RE: Unit B/C Phase III - Food Service Facility - Floor Two

Subject: Unit B/C - Phase III
Food Service Facility

Subject: Preliminary Plan Review - Food Service Unit BC

UNIT B/C PARTIAL FIRST FLOOR PLAN (WEST) LIGHTING

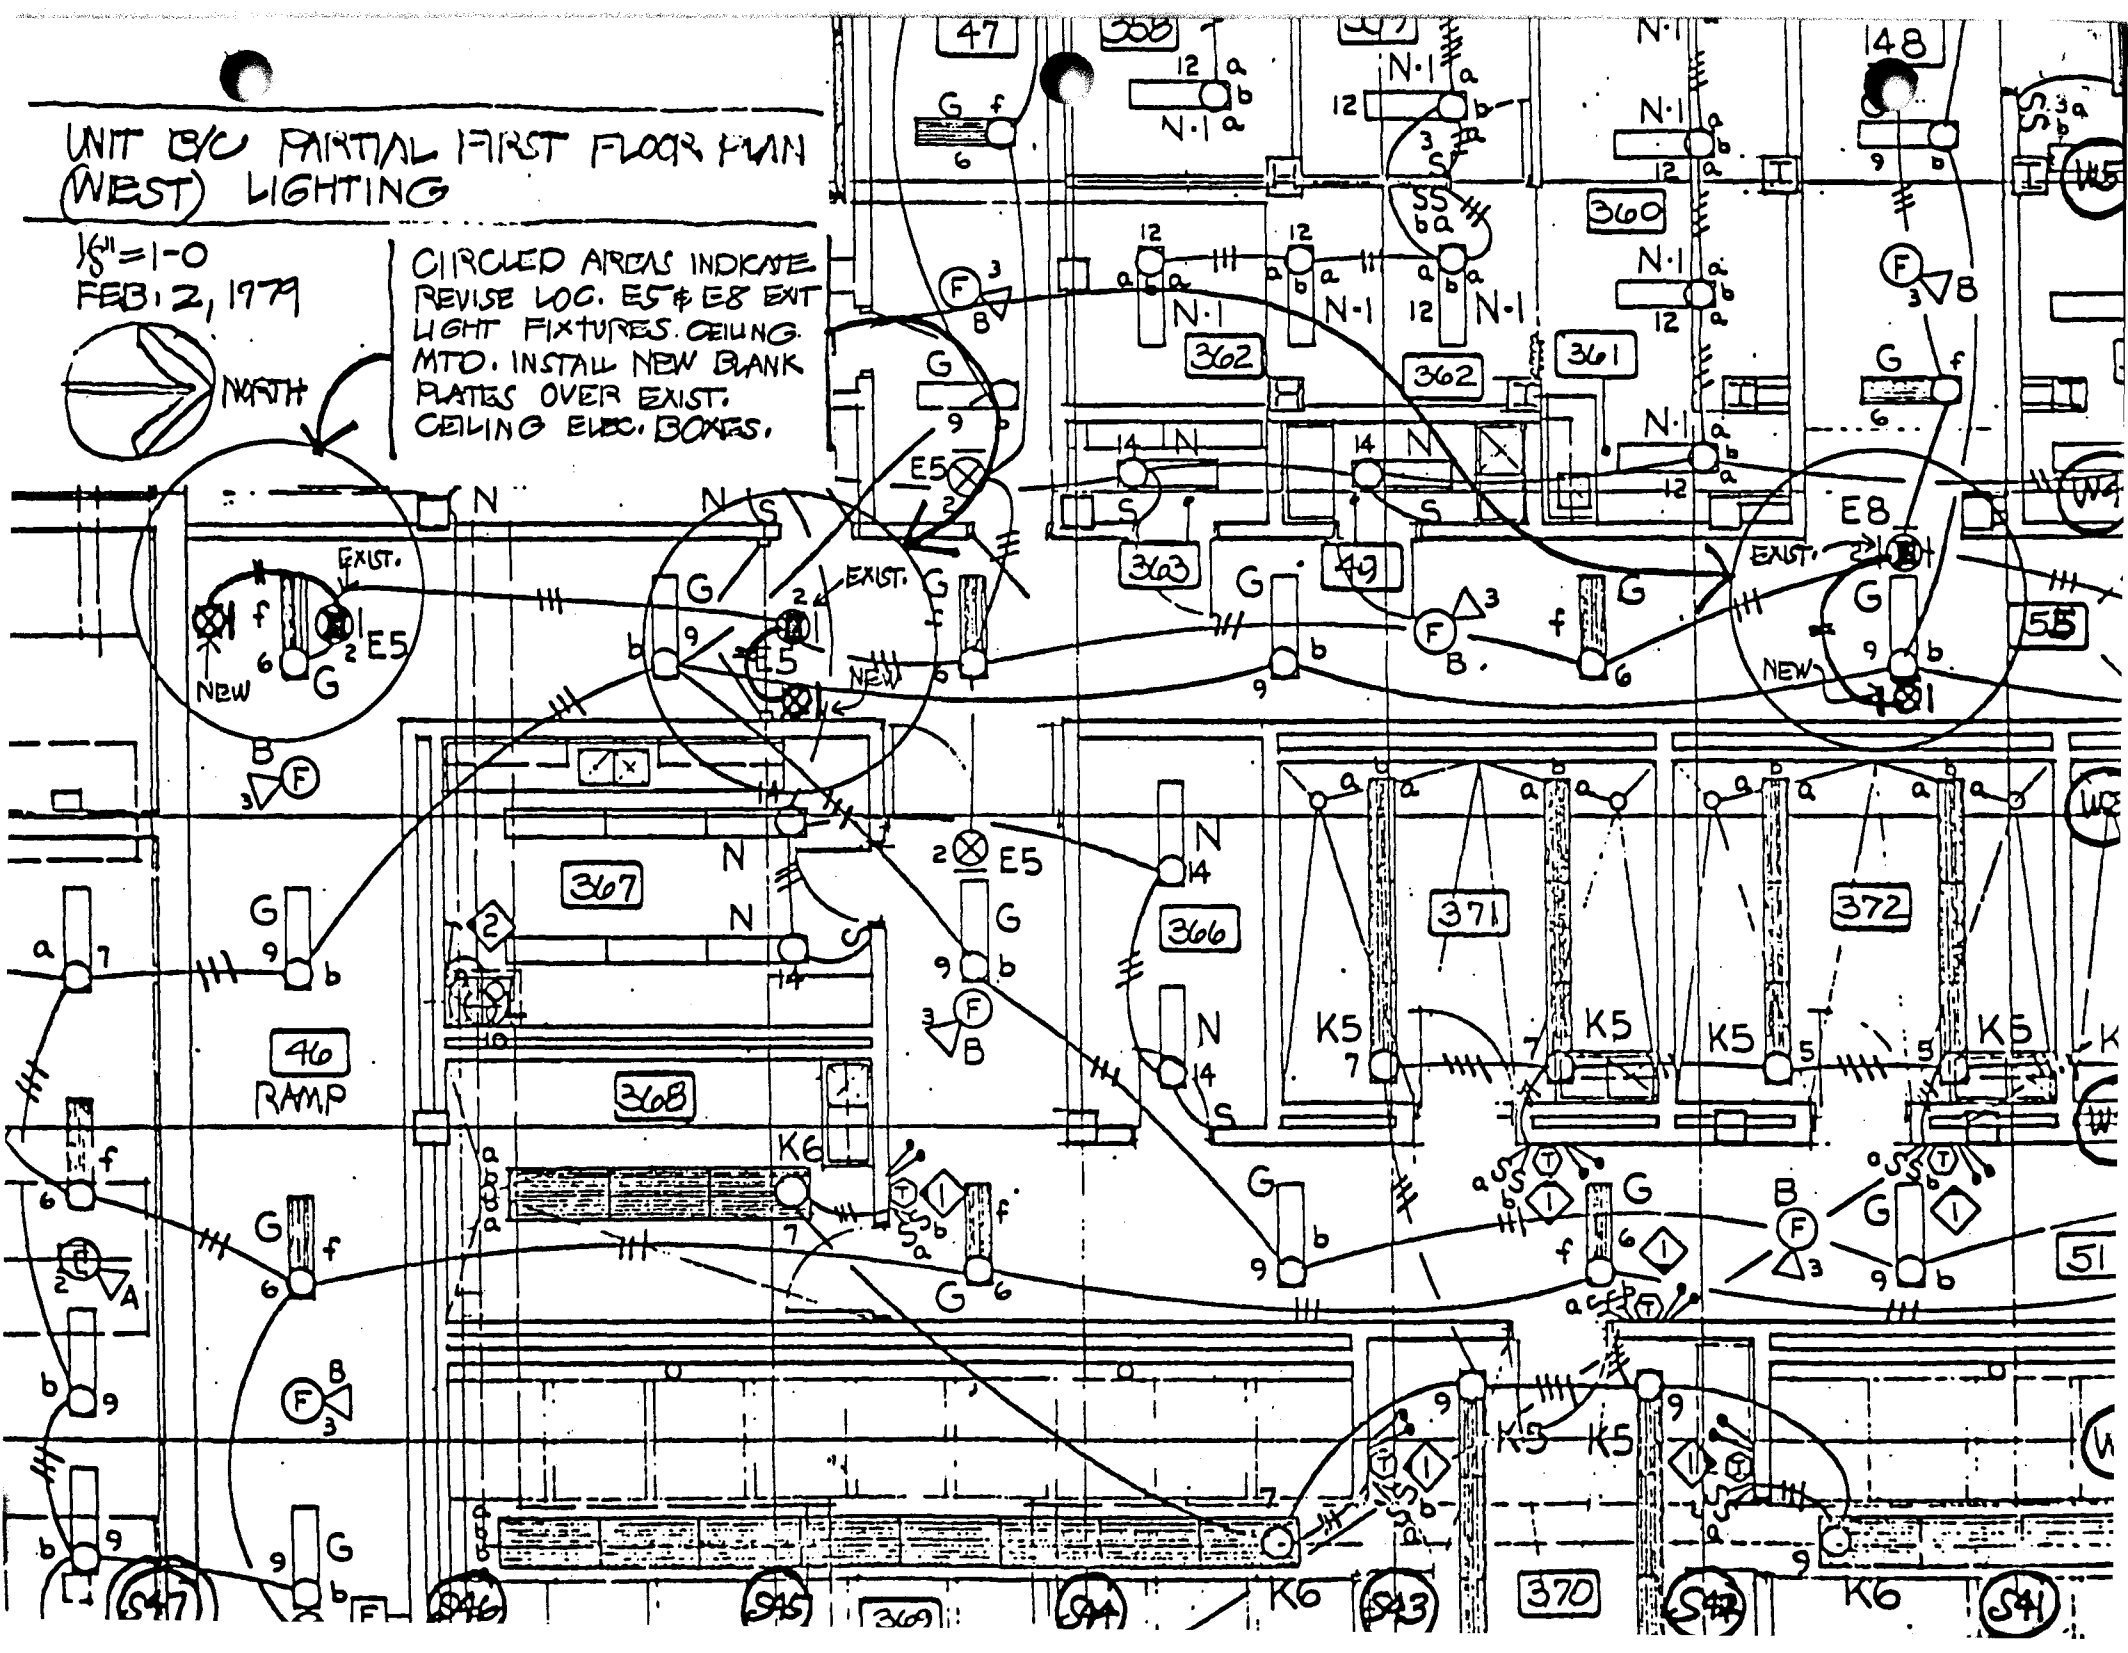
CIRCLED AREAS INDICATE REVISE LOC. E5 & E8 EXT LIGHT FIXTURES. CEILING MTD. INSTALL NEW BLANK PLATES OVER EXIST. CEILING Elec. BOXES.

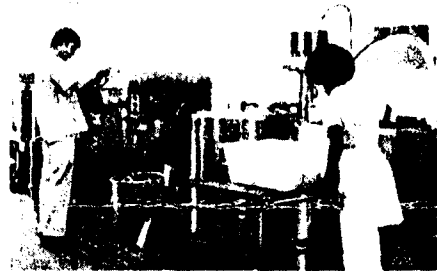
4. A dry chemical fire extinguisher system will be used in the hood above the grills and fryolaters. The cylinders for this fire extinguisher equipment will need to be installed in a cabinet with smooth, washable walls.

1 SECTION @ TELEPHONE CABINET 3" = 1'-0"

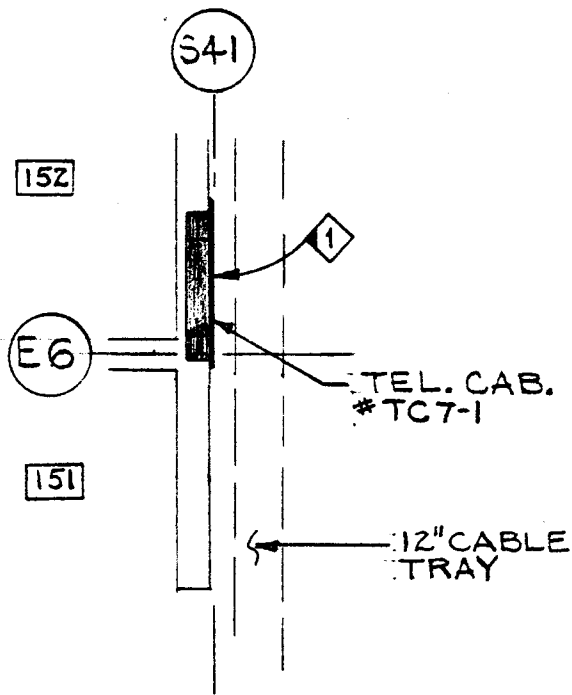
10. Metal door and frame to telephone cabinet, detail 1/1 of 1, Appendix A, Addendum #2.

SHEET NO
APPENDIX
C
SHEET-1

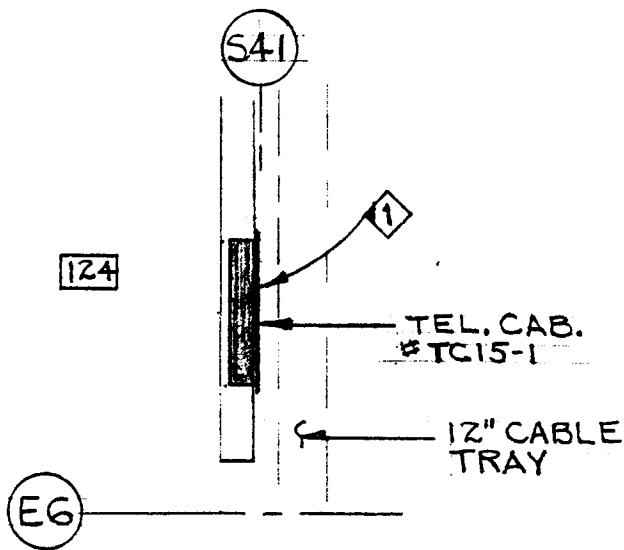
(B) Furnish and install a 3" x 6" wireway from telephone cabinet to cable tray above ceiling. See attached drawing, Appendix C, drawing #1.

(B) Furnish and install a 3" x 6" wireway from telephone cabinet to cable tray above ceiling. See attached drawing, Appendix C, drawing #1.

① PROVIDE 3"X6" WIREWAY UP FROM TELEPHONE CABINET TO CABLE TRAY ABOVE CEILING. TELEPHONE CABINET PROVIDED BY GENERAL CONTRACTOR. SEE ATTACHED ARCHITECTURAL DETAILS.
